**Aumsville, Oregon  
Wastewater Treatment Plant Improvements  
ADDENDUM NO. 3**

**OWNER:**      **The City of Aumsville, Oregon**

**FROM:**       Westech Engineering, Inc.

**DATE:**        **July 10, 2026**

DRAWING  
E301  
186 OF 223  
JOB NUMBER  
2599.3220.0

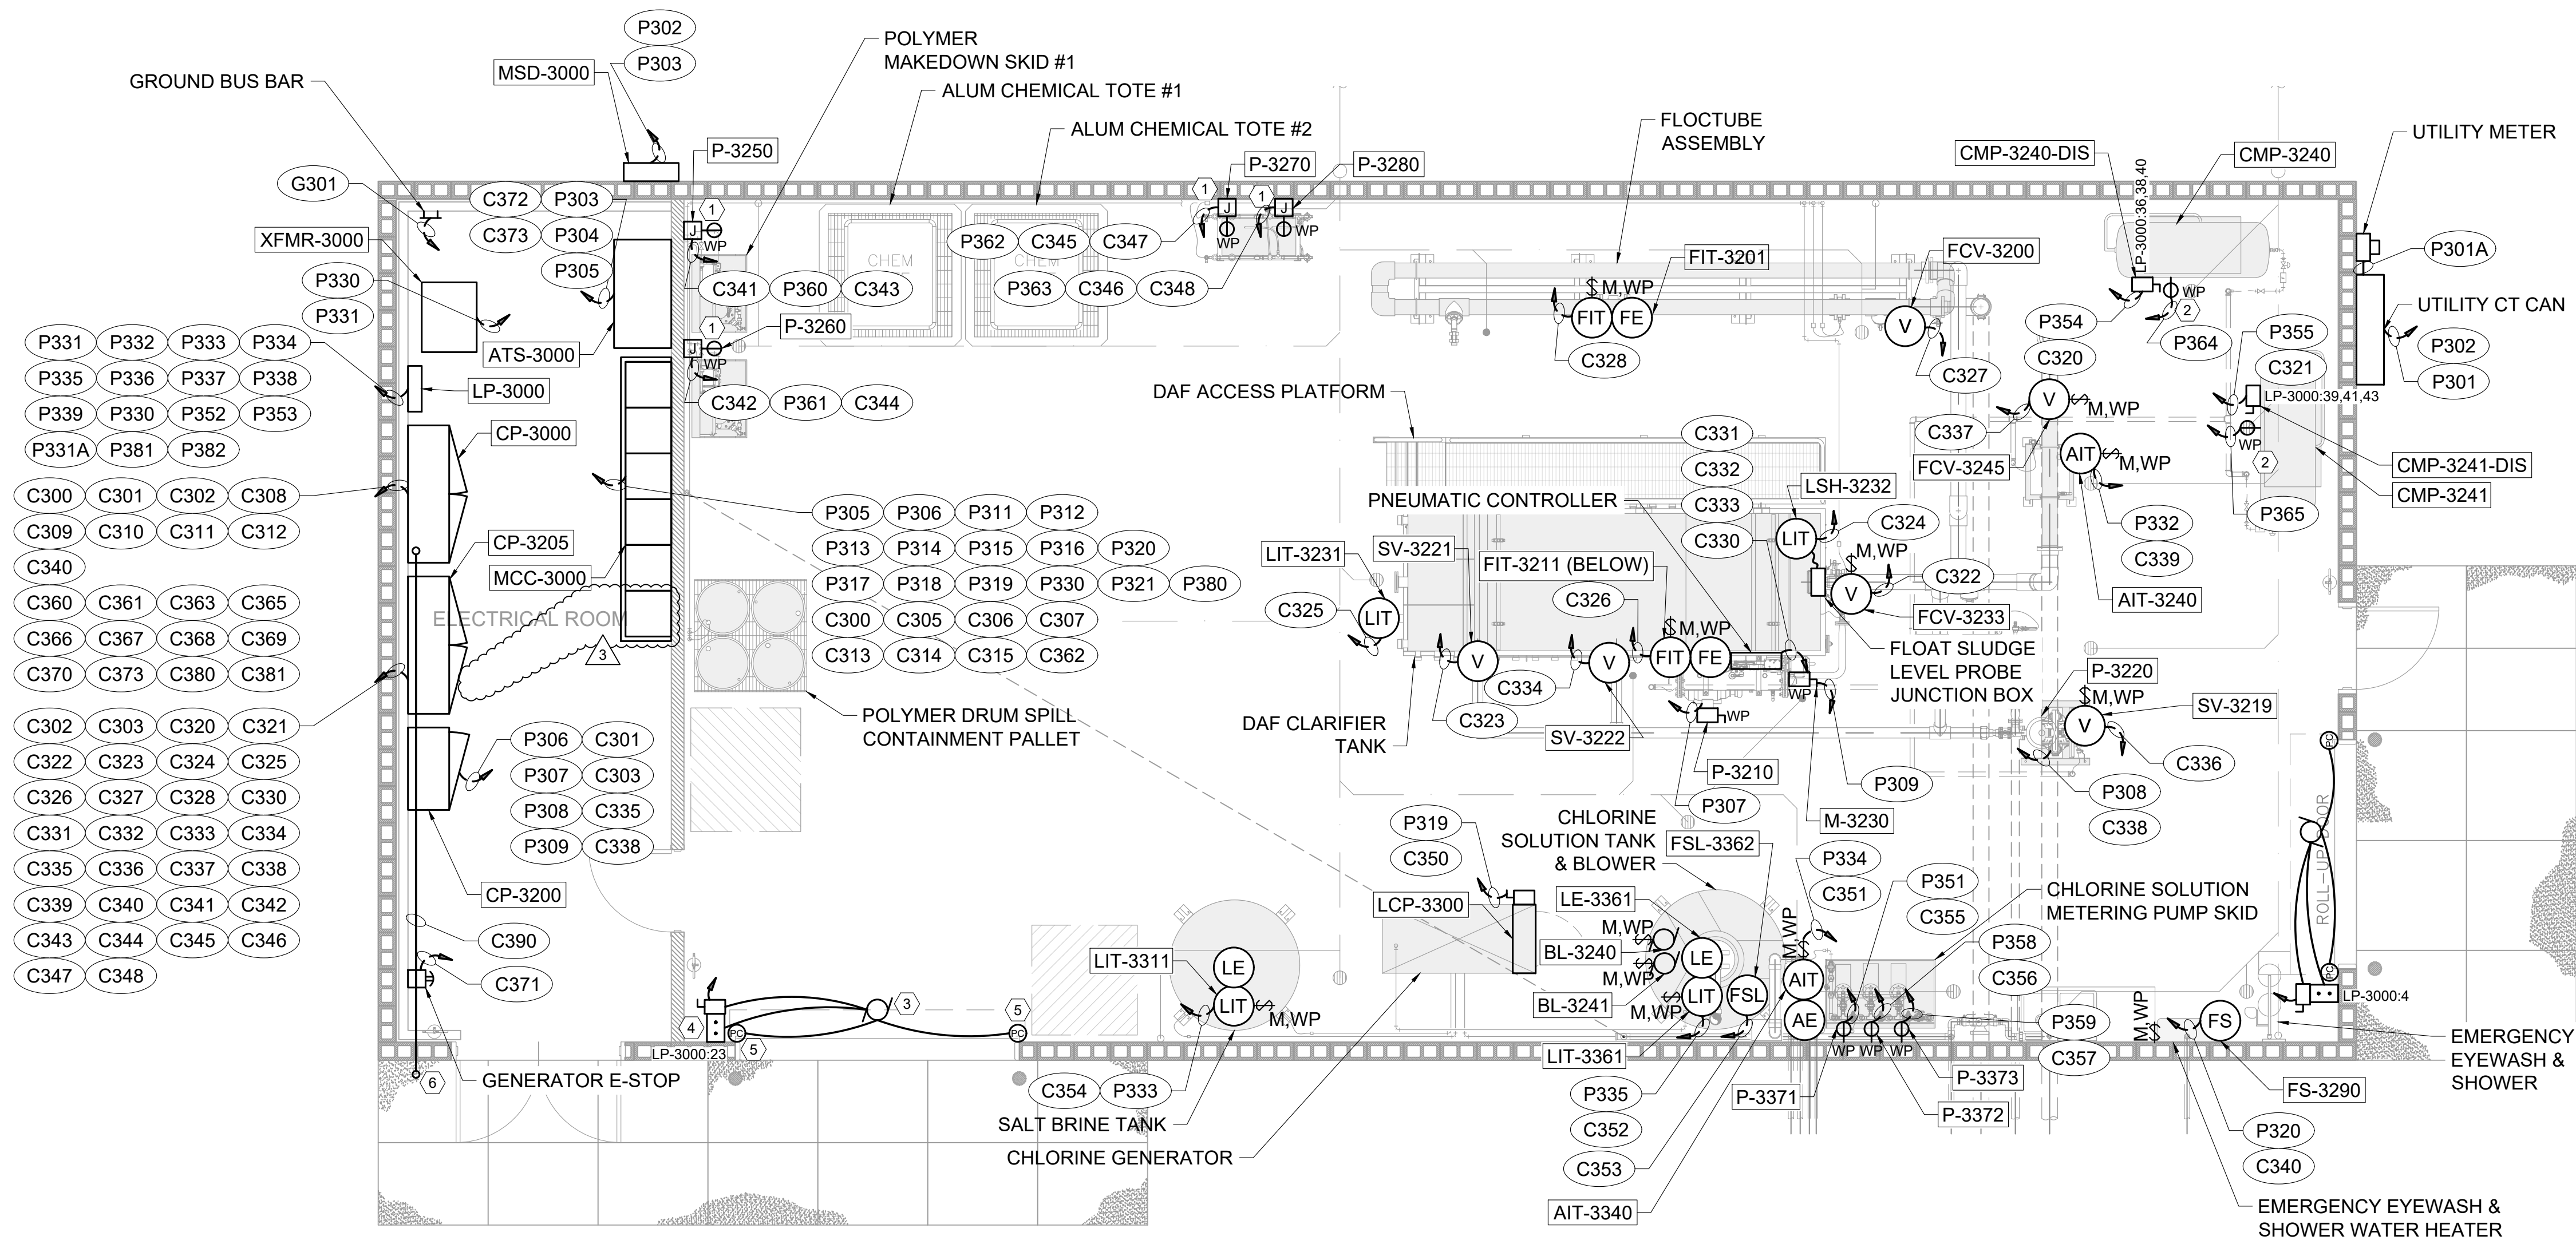
20. Drawing E301 (DAF MCC Elevation)
  - a. Delete this sheet entirely and replace with the revised drawing E301 attached hereto. Revised DAF MCC-3000 elevation to match Owner Furnished MCC.
